LINEAR
INFRASTRUCTURE
STANDARDS
2021

March 3rd, 2021

Revisions to 2021 Linear Infrastructure Standards

If you keep a printed copy of the LIS you will need to replace the following sections due to text clean-up, deletions and revisions.

SERVICE CONNECTIONS FOR NEW DEVELOPMENTS OR UNSERVICED LOTS

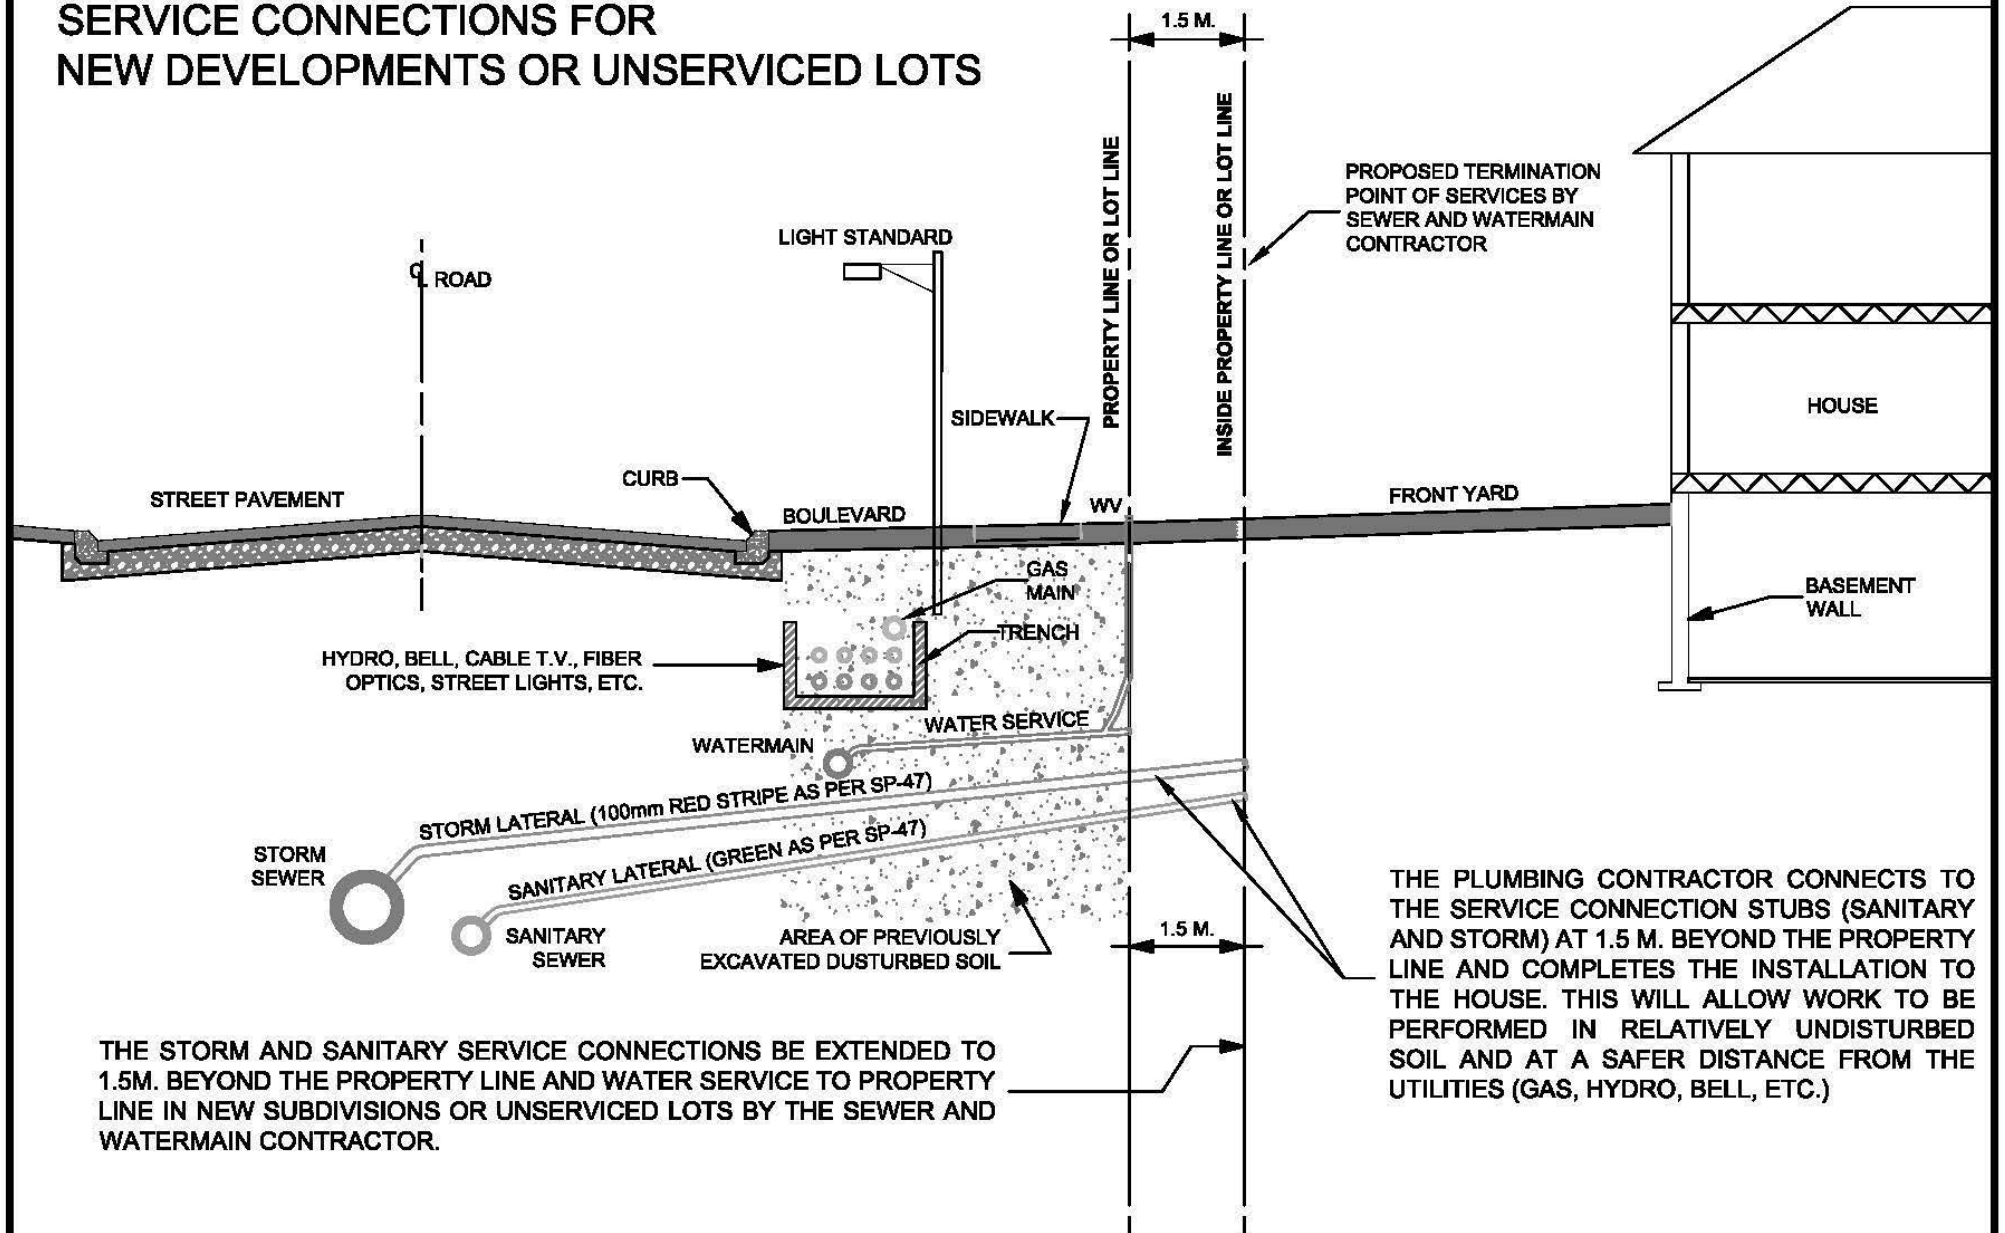
Drawing Number	Deletions & Revisions
3-21	Service Connections for New Developments and Unserviced Lot Revised to reflect SP-47 color requirements for service laterals
3-55	Sewer and Watermain Laterals: Drawing revised to reflect SP-47 color requirements for service laterals

CITY OF GUELPH STANDARD DRAWING		DATE DRAWN : AUG/88	REV. No. : R-12	 Guelph <small>Making a Difference</small>
TYPICAL CROSS SECTION FOR 10m & 8.8m ROADS - 20m R.O.W.		DESCRIPTION : REVIEWED FEB/2021		
		REV. DATE : FEB/21	REV. BY. : J.B./I.U.	5 - 48
		APPROVED BY: _____

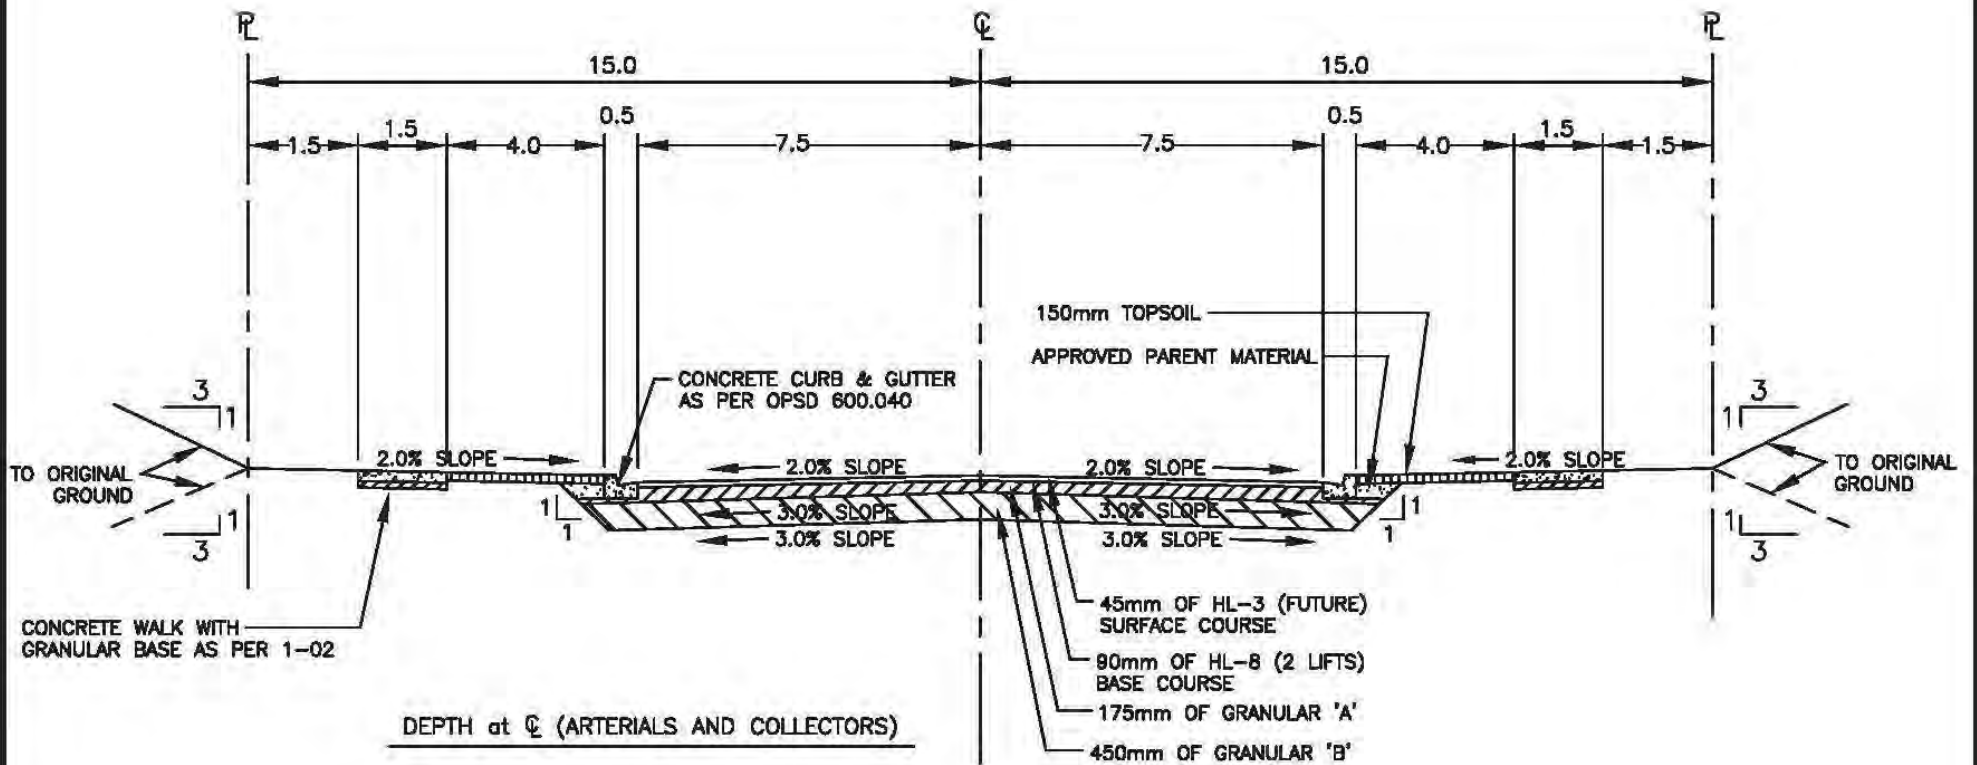
Drawing Number	Deletions & Revisions
5-48, 5-48a, 5-48b, 5-49, 5-49a, 5-49b, 5-49bb & 5-49c	Revised: Asphalt pavement width to be measured to pavement edge. The drawings were labelled with asphalt pavement width plus 0.5m curb and gutter

CITY OF GUELPH STANDARD DRAWING		DATE: YY/MO/DAY 20/12/04	
PAVEMENT MARKING DETAIL - YIELD TO PEDESTRIAN LINE		APPROVED BY: _____	
		REVISION: _____	9 - 403
		DATE: YY/MO/DAY

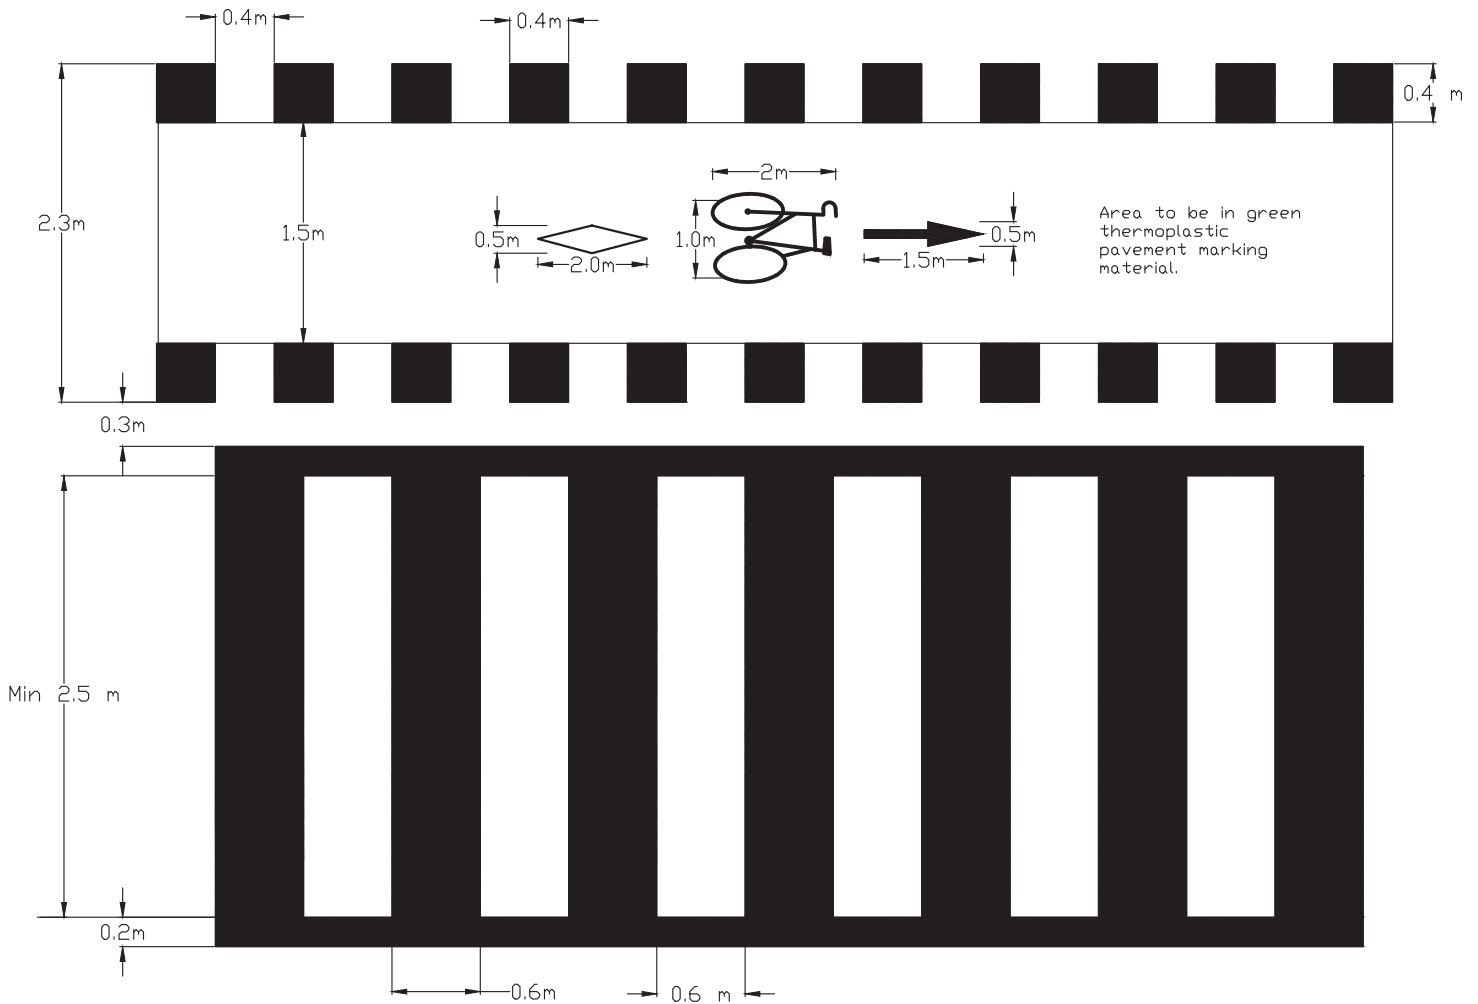
Drawing Number	Deletions & Revisions
9-307	Drawing DELETED as per AODA requirements
9-403	Pavement Marking Detail Yield to Pedestrian Line: Drawing revised to reflect new dimension requirements
9-404	Pavement Marking Detail Separated Crossride (2.3m width): Drawing revised to reflect new pavement marking requirements
9-407	New Drawing: Traffic Calmed Neighborhood Sign
9-408	New Drawing: Pavement Marking Detail Combined Crossride
9-409	New Drawing: Pavement Marking Detail Mixed Crossride
9-410	New Drawing: Pavement Marking Detail Separated Crossride (two-way)
9-411	New Drawing: Emergency Access Route Signs
